## **EXTINGUISH THE TORCH MEETING SESSION ONE**

Project: Turnpike Mainline Shoulder Excavation NB (MP 140-210)

# **LESSONS LEARNED**

## **SUMMARY REPORT**

2) H-20 Loaded Traffic Grate for Drainage Structure S-1

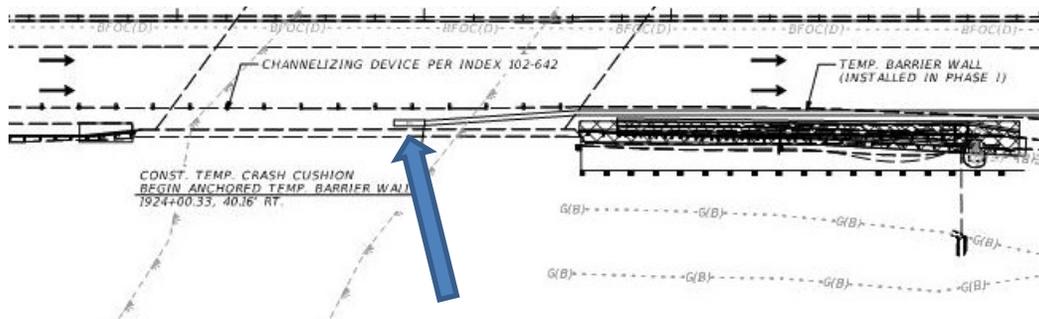
During Shop Drawing review the Turnpike & EOR required Ranger to provide a H-20 Loaded Traffic Grate for Structure S-1, which was not identified in the plans.

EOR should include in the remarks the requirements of H-20 loading for all shoulder gutter inlets for all future Turnpike projects.

Contractor agreed to provide the H-20 loaded grate at an addition cost to the Turnpike. This was processed with Work Order.

### 3) Location of Crash Cushion on Bridge

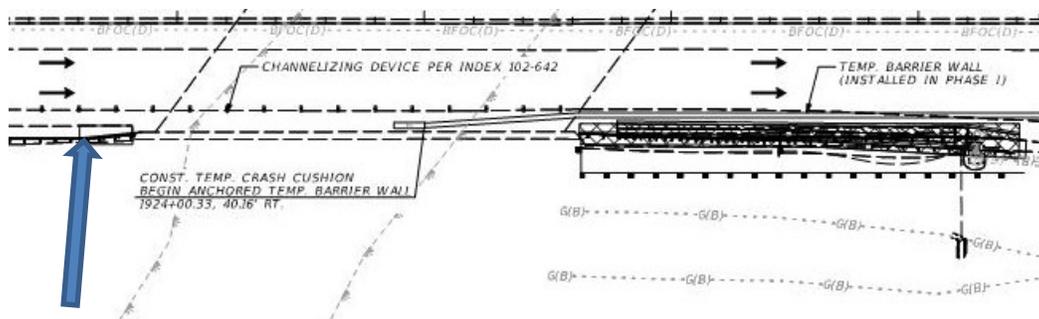
Sheet 37 depicted installation of a Temporary Crash Cushion on a Bridge, which could cause unavoidable impacts to the structural integrity of the bridge (cut tendons or reinforcing bars depending on bridge construction).

The EOR should pay attention to the placement of the Crash Cushions and not propose crash cushions to be installed on bridges unless it unavoidable. Most crash cushions require the placement of 10 to 20 bolts/anchors to be installed in a confined area which has the potential to impact the reinforcing and/or structural steel causing significant impacts to the capacity and service life of the bridge.

The EOR agreed with the CEI recommendation the crash cushion to be relocated to Station 1922+50 from 1923+92. This required 140 feet of additional barrier wall paid for by overrunning the quantity.
